Mack Energy Glacier SWD-2617

Miscellaneous E-mails

- Follow-up on permit status
- E-mail and Map showing AOR deficiencies from original C-108 submission
- Lack of data for FSP analysis & Waiver Response
- Water Sample for Devonian

Subject: Mack Energy Glacier SWD#1 - List of deficiencies and clarification required.

OCD Well Locations

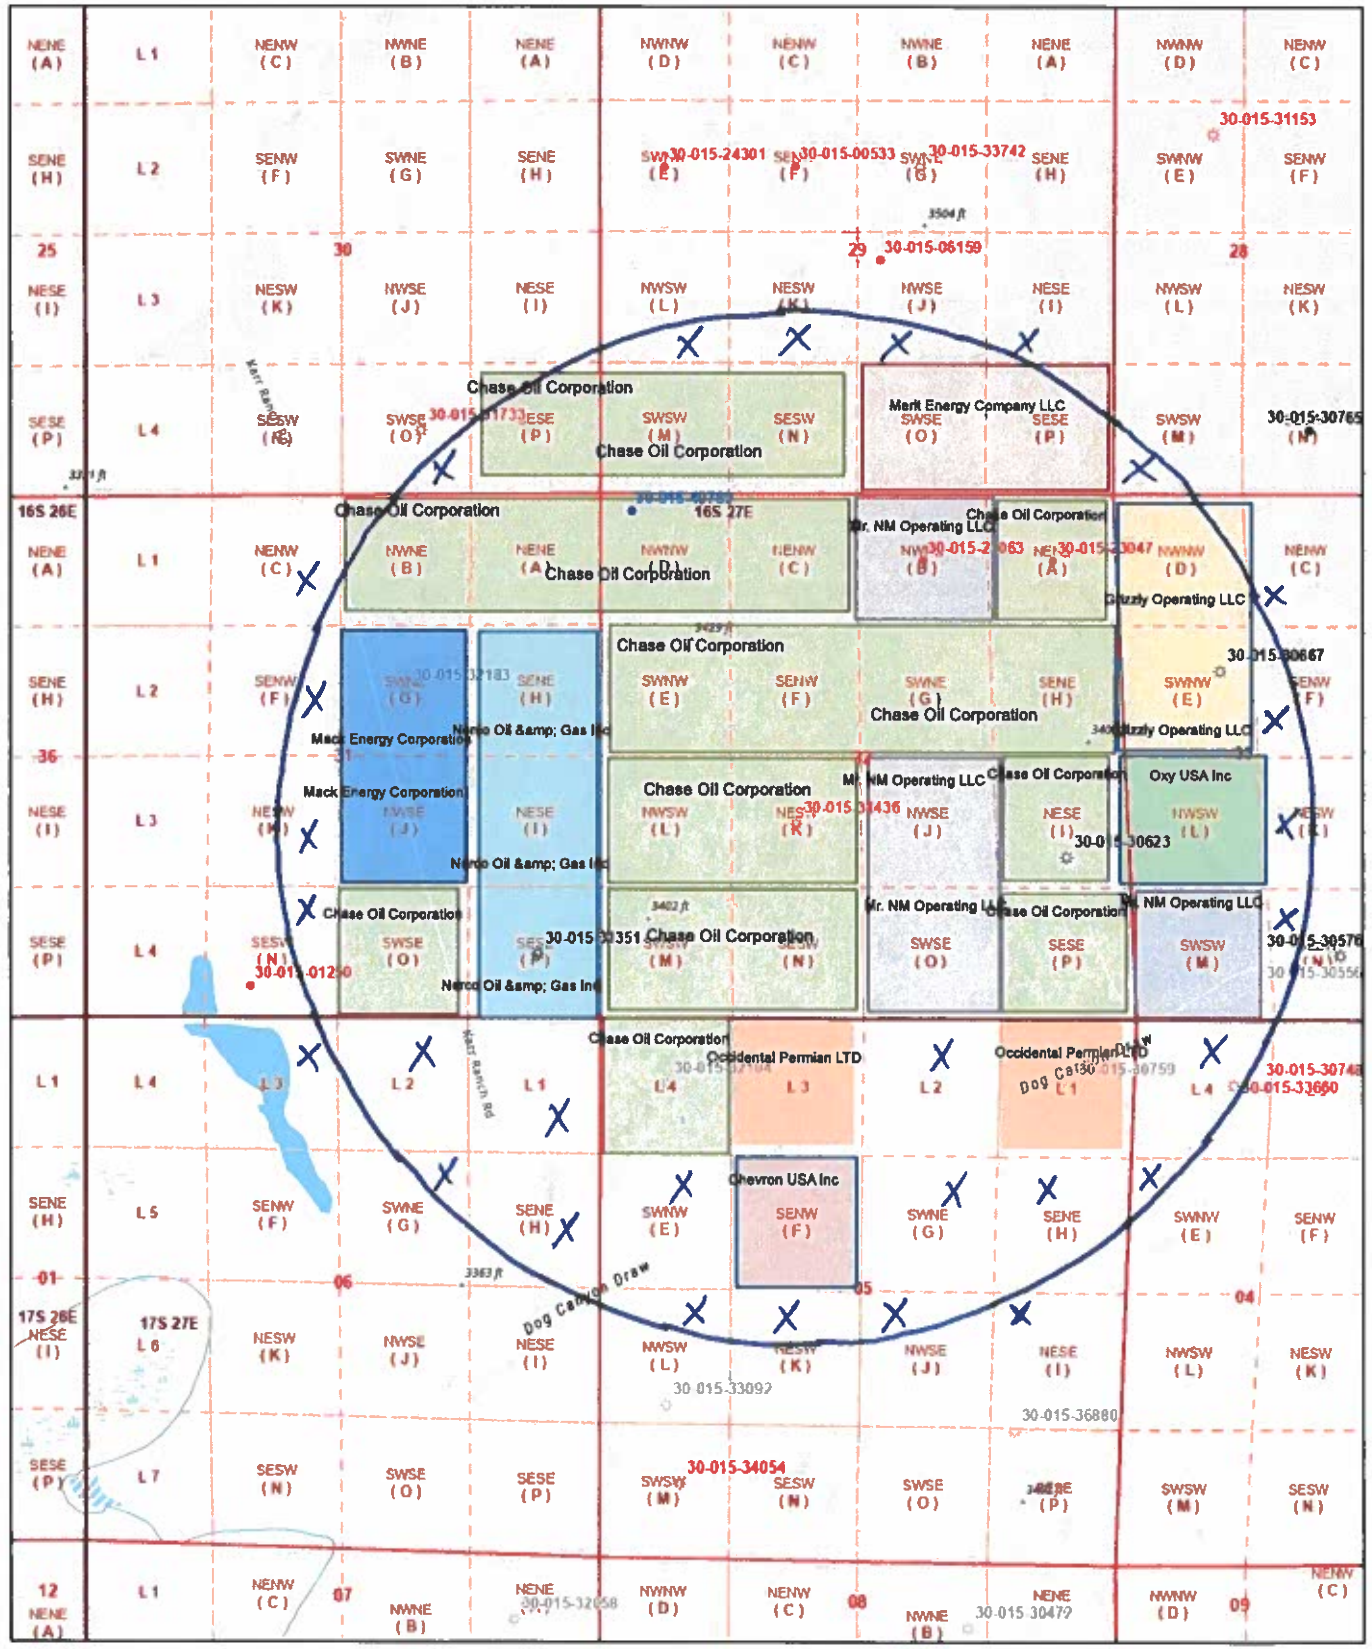
- a. 1-Mile AOR not shown on this map.
 - i. Refer to attached map labelled “**Page 22.. AOR deficiencies**” illustrating the unit letters (denoted by X’s) that need to be included to encompass the 1-mile AOR

1. Please update the map on Page 22 to include a circle clearly showing the 1-mile AOR.
 2. Please update “proof of notice” requirement to verify that the surface owner and lease operators (ie. including the 30 Unit letters denoted by an “X” in the attached map) have been notified (**Refer to item 5b below**)
